Licence Number L6942/1997/13

Licence Holder BHP Billiton Iron Ore Pty Ltd

Premises Eastern Ridge Iron Ore Mine
Mining Tenement ML244SA within coordinates MGA Zone 50:
NEWMAN WA 6753
As depicted in Schedule 1, Maps and co-ordinates

Amendment

13. Schedule 1, Maps and coordinates, Map 1 is amended by the deletion of the following figure and replaced with an updated Premises Map.

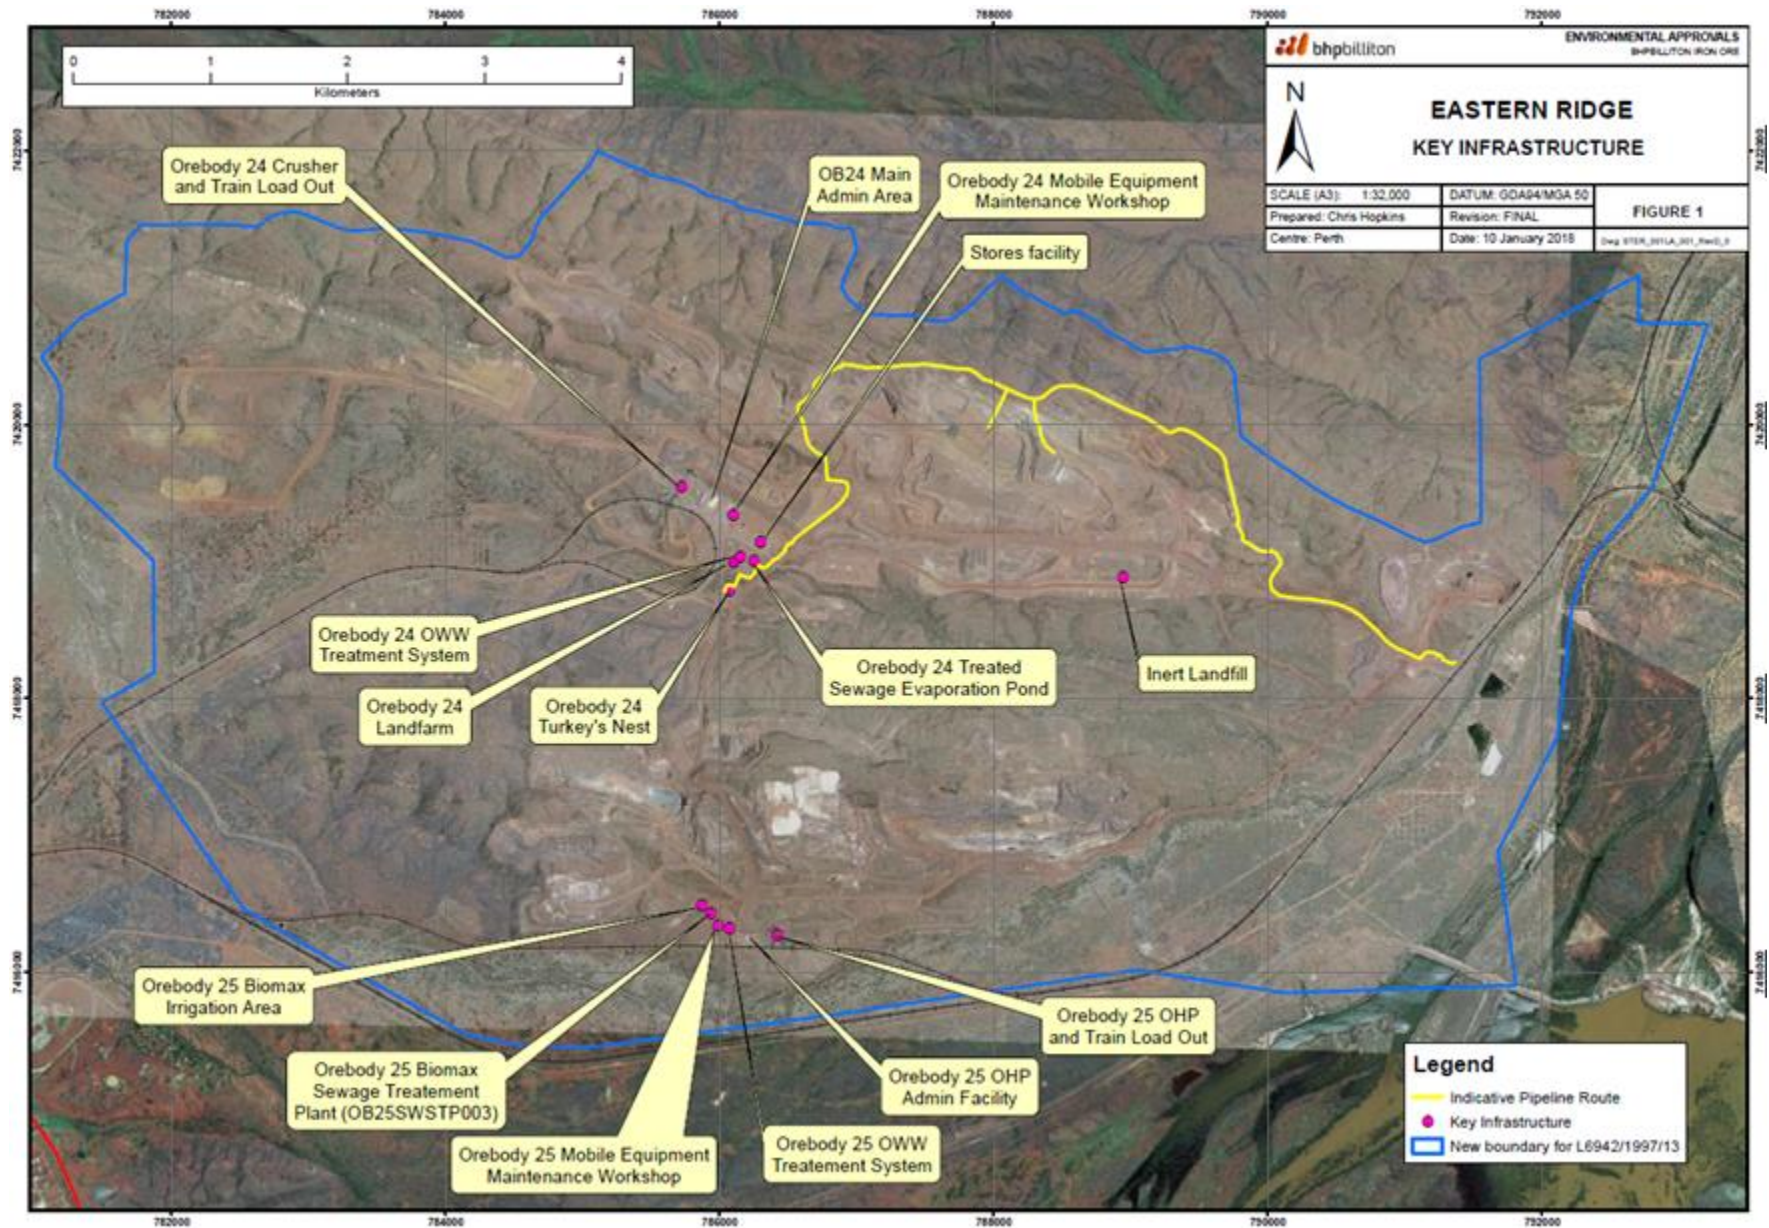
Amendments to the map comprise:

- The amended Premises boundary;
- New location of the (previously approved) inert landfill;
- New dewatering discharge pipeline route from orebody 24 to an existing dewatering discharge pipeline (that leads to DO4-4);
- OB24 Biomax Irrigation Area, removed: This facility no longer exists and has been decommissioned (previously approved).
- Orebody 24 Landfarm: This point has been added back onto the map.
- Orebody 25 Landfarm, removed: This facility has been decommissioned and all contaminated soil was moved to the Orebody 24 Landfarm.
- Orebody 24 OWW Treatment System: This point was removed as it is the treatment location, not the discharge point. The treated water goes to the Orebody 24 Turkey's Nest which is shown on the map and is Monitoring Reference Point P1 (Condition 3.5.1, Table 3.5.1).

15. Schedule 1, Maps and coordinates, Map 3 – Licence monitoring points is a new map for the licence.

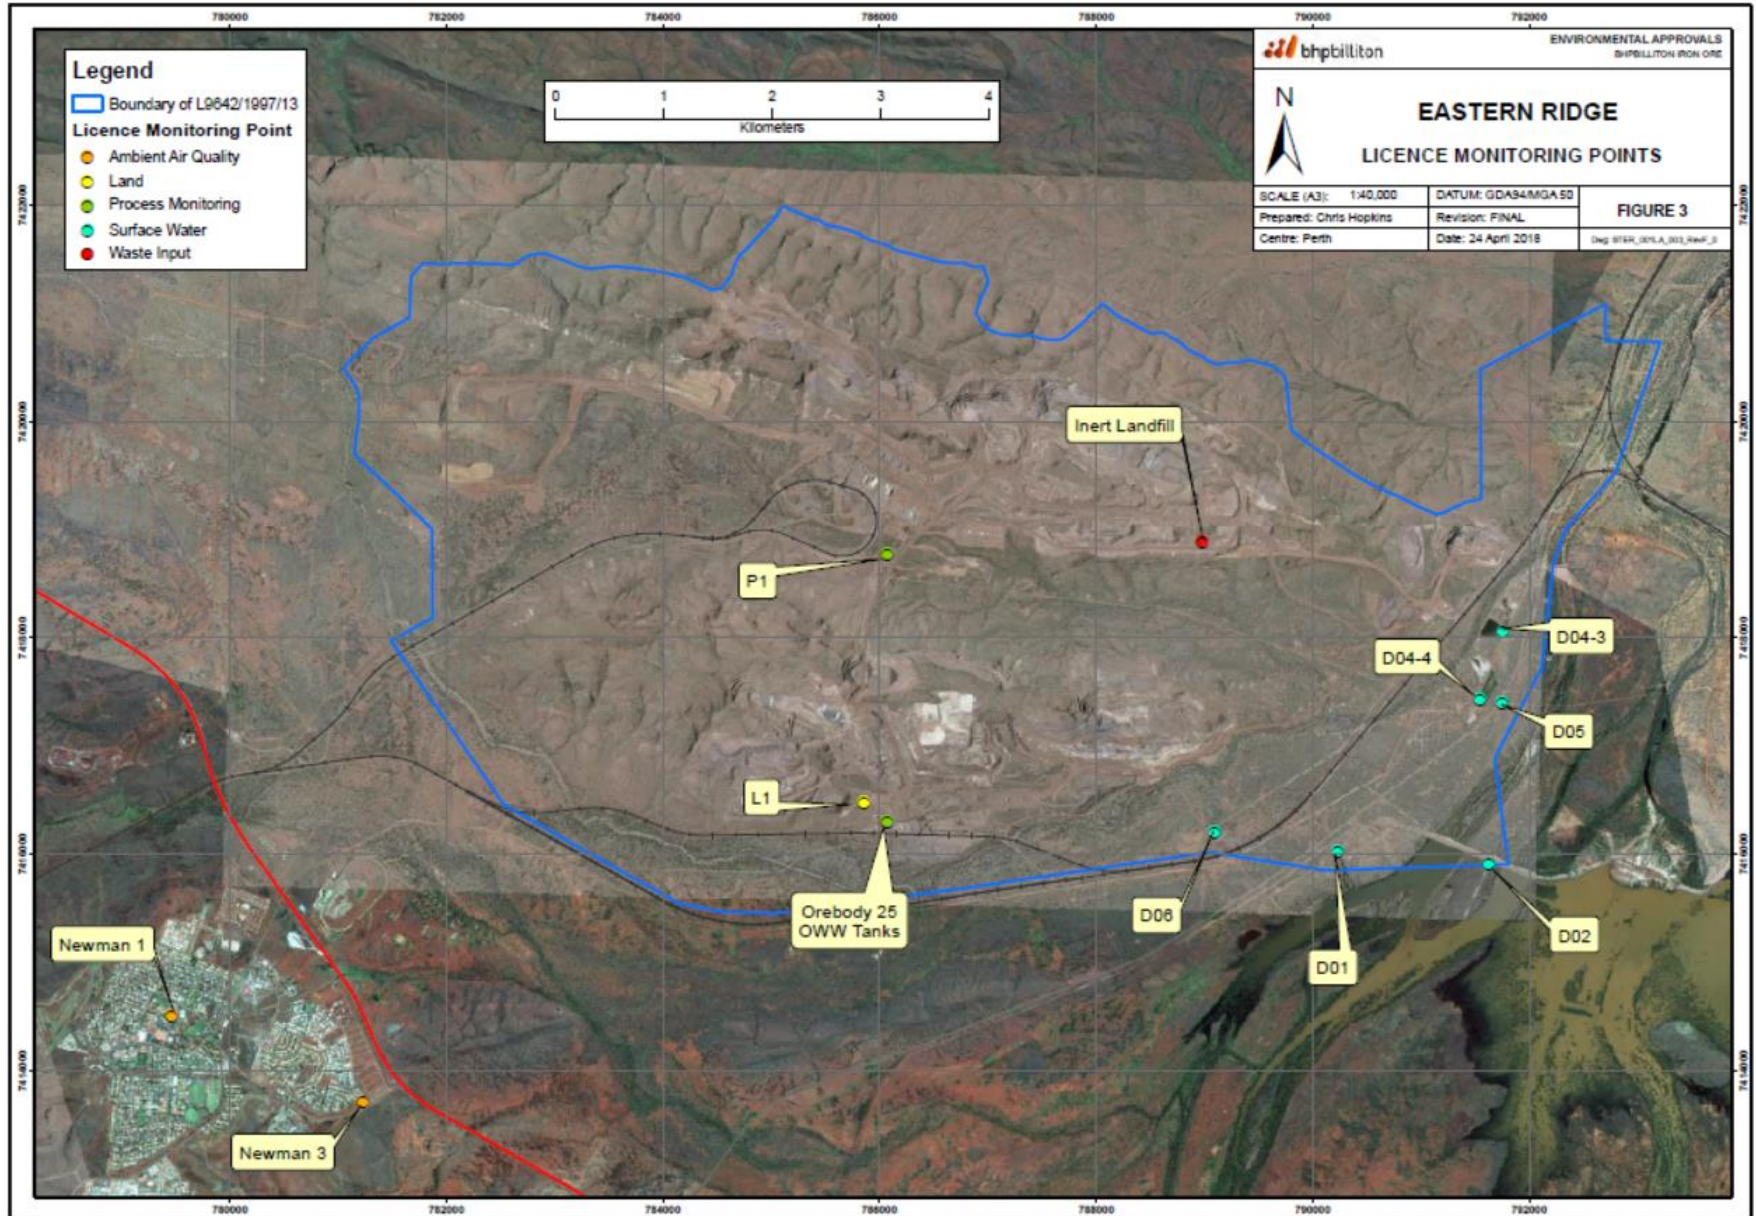
The map comprises:

- Air quality monitor locations: Newman 1 ('Town Centre')(WBAQRT010) and Newman 3 ('Newman East')(WBAQRT006) McLennan Drive monitors;
- Land discharge monitoring location (treated effluent);
- Process monitoring (treated waste water from oil water separators);
- Surface water monitoring (emissions to surface water);
- Waste input monitoring location (inert landfill); and
- The amended Premises boundary.
